STAFF REPORT: 2/8/2023 MEETING

ADDRESS: 1310 LABROSSE

HISTORIC DISTRICT: CORKTOWN

SCOPE OF WORK: CONSTRUCT SECOND STORY ON APPROVED GARAGE

1310 Labrosse, Sanborn Map 1971

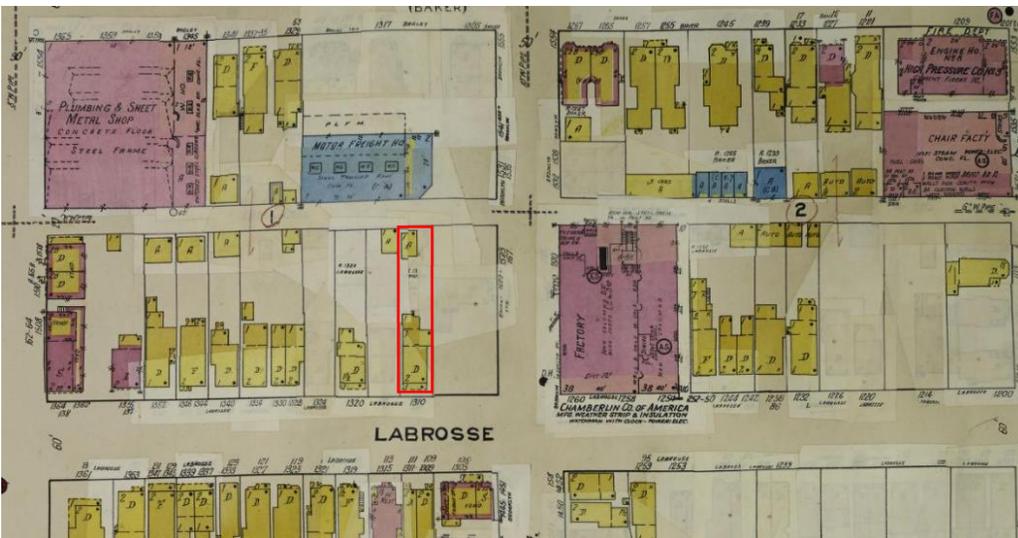
- A Sanborn Fire Insurance map from 1971 indicates that a garage had been extant in the rear yard, at the location of the proposed new garage. Currently, only a slab remains at this location. It is unclear to staff when the garage was demolished/if it was demolished prior to the district's designation
